HARBOR ISLE 2ND ADDITION

Re: S/D 97-59 - One-Step Final Plat of HARBOR ISLE 2ND ADDITION

**STAFF REPORT
(One-Step Final Plat)**

CASE NUMBER: S/D 97-59 HARBOR ISLE 2ND ADDITION

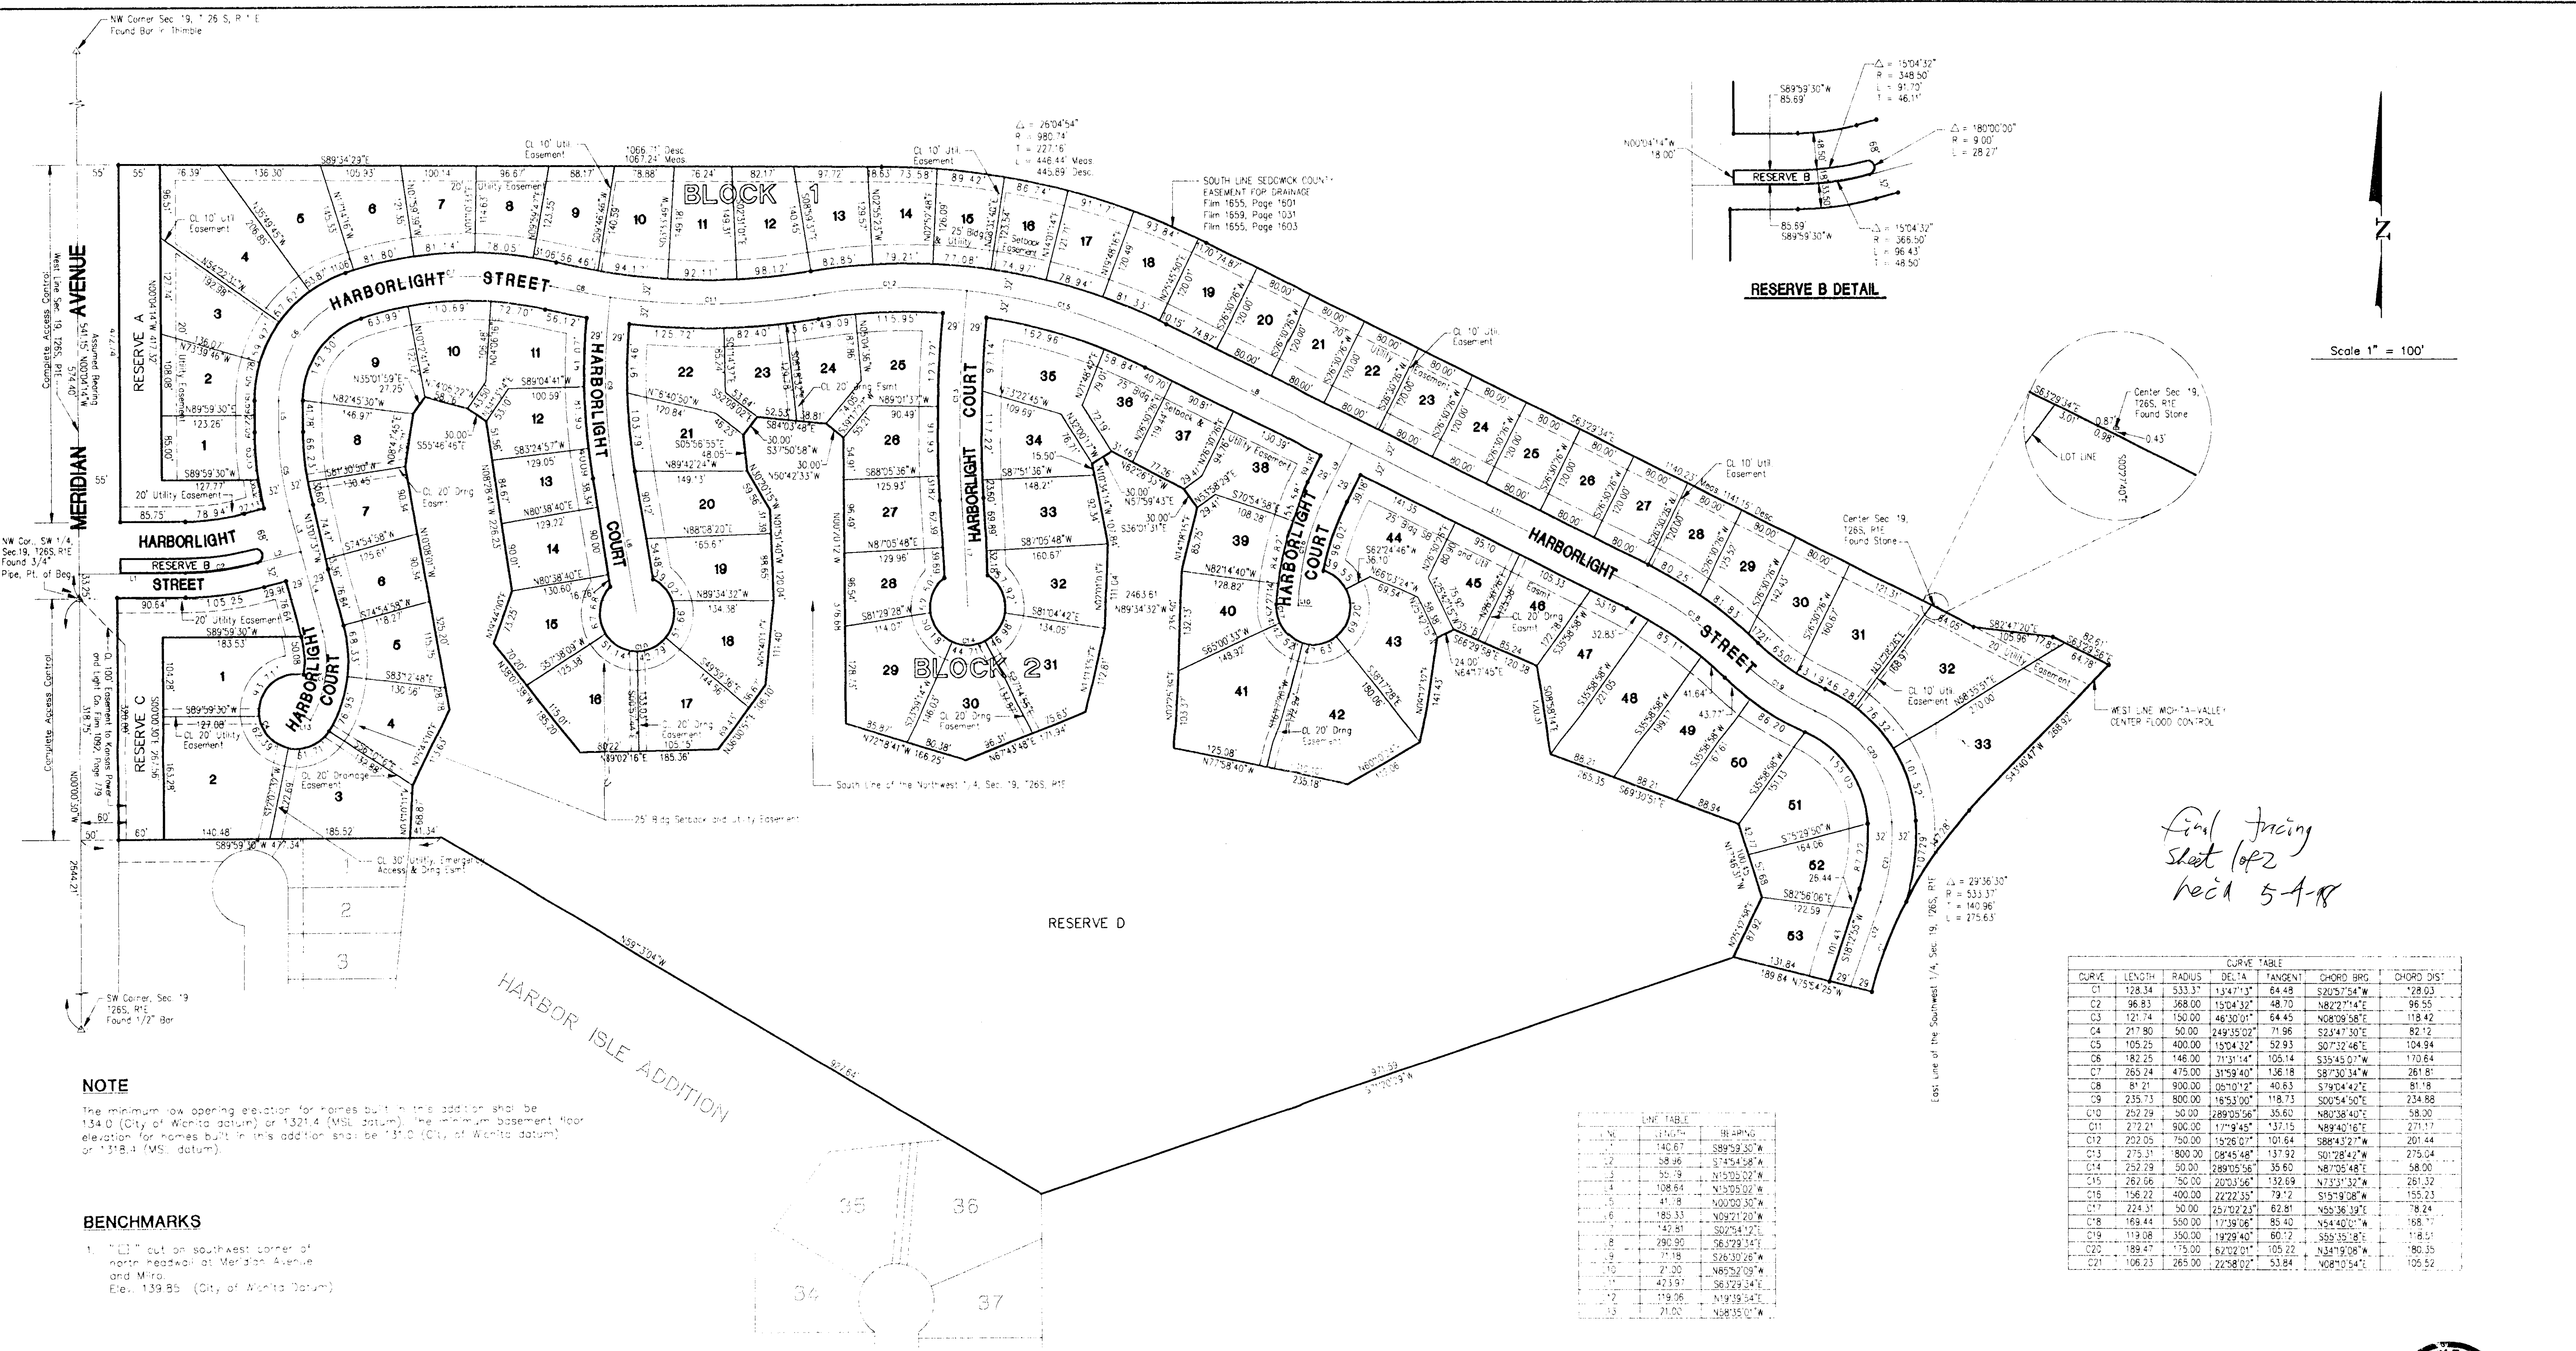
- A. The applicant shall guarantee the extension of City water to serve the lots being platted.
- B. The applicant shall guarantee the extension of sanitary sewer to serve the lots being platted.
- C. The applicant shall guarantee the paving of the proposed interior streets. As a through-type street, sidewalks will be required along one side of Harborlight Street.
- D. The applicant shall guarantee construction of any storm sewers required by this plat.
- E. If improvements are guaranteed by petition, a notarized certificate listing the petitions shall be submitted to the Planning Department for recording.
- F. At the terminus of Harborlight Street on the south line of this plat a temporary cul-de-sac should be constructed. A temporary easement will need to be established by separate instrument.

- G. **Traffic Engineering** should comment on any improvements needed to Meridian Avenue at this time. *No improvements are needed.*
- H. **City Engineering** should comment on the status of the applicant's drainage plan as well as the minimum low opening elevations shown on the plat. *The drainage plan is approved.*

- K. Reserve D, containing the lake, adjoins Reserve F in the Harbor Isle Addition along the southwest portion of this plat which also contains the lake. Both of these reserves shall be owned and maintained by the same entity, and referenced as such in the plat's text. *The applicant shall submit a document indicating that transfer of ownership of Reserve D to the owner of Reserve F in the Harbor Isle Addition will occur subsequent to excavation of the channels.*

- M. The representatives from the utility companies should be prepared to comment on the need for utility easements to be platted on this *property. KGE has requested additional easements. Southwestern Bell has requested that a utility easement be established within the emergency access easement.*

- U. City Fire Department should comment on the appropriateness of the street names. *The street names are acceptable. At the terminus of Harborlight Street on the south line of this plat a temporary cul-de-sac (50-foot radius) should be constructed.*

- V. The Chairman of the MAPC signature block should be amended to read Richard Lopez.
- W. In regard to the emergency access easement across lots 2 and 3 in Block 2, no obstructions will be allowed in this easement except for any gates as is approved by City Fire Department. The applicant will be responsible for the installation of an acceptable driving surface or other improvements as is determined by City Fire Department.

- Y. The applicant needs to revise the legal description to accurately portray the land being platted. The distances and degrees for the southeastern lines of the plat are not identical to the legal description.
- Z. The final plat tracing should replace references to 1997 with 1998.

- C. The applicant shall guarantee the paving of the proposed interior streets. As a through-type street, sidewalks will be required along one side of Harborlight Street.

- F. At the terminus of Harborlight Street on the south line of this plat a temporary cul-de-sac should be constructed. A temporary easement will need to be established by separate instrument.

- G. Traffic Engineering should comment on any improvements needed to Meridian Avenue at this time.
- H. City Engineering should comment on the status of the applicant's drainage plan as well as the minimum low opening elevations shown on the plat.

- K. Reserve D, containing the lake, adjoins Reserve F in the Harbor Isle Addition along the southwest portion of this plat which also contains the lake. Both of these reserves shall be owned and maintained by the same entity, and referenced as such in the plat's text.

- L. It is recommended that access to Reserve D be created with access easements or extending finger-like areas of reserves to the cul-de-sacs between the lots to increase the accessibility and usefulness of Reserve D for all homeowners in the Addition, in addition to ease of maintenance.

- X. In regard to the emergency access easement across lots 2 and 3 in Block 2, no obstructions will be allowed in this easement except for any gates as is approved by City Fire Department. The applicant will be responsible for the installation of an acceptable driving surface or other improvements as is determined by City Fire Department.

- Y. The applicant should be prepared to comment on the need for the front yard utility easements denoted on the plat.
- Z. The applicant needs to revise the legal description to accurately portray the land being platted. The distances and degrees for the southeastern lines of the plat are not identical to the legal description.
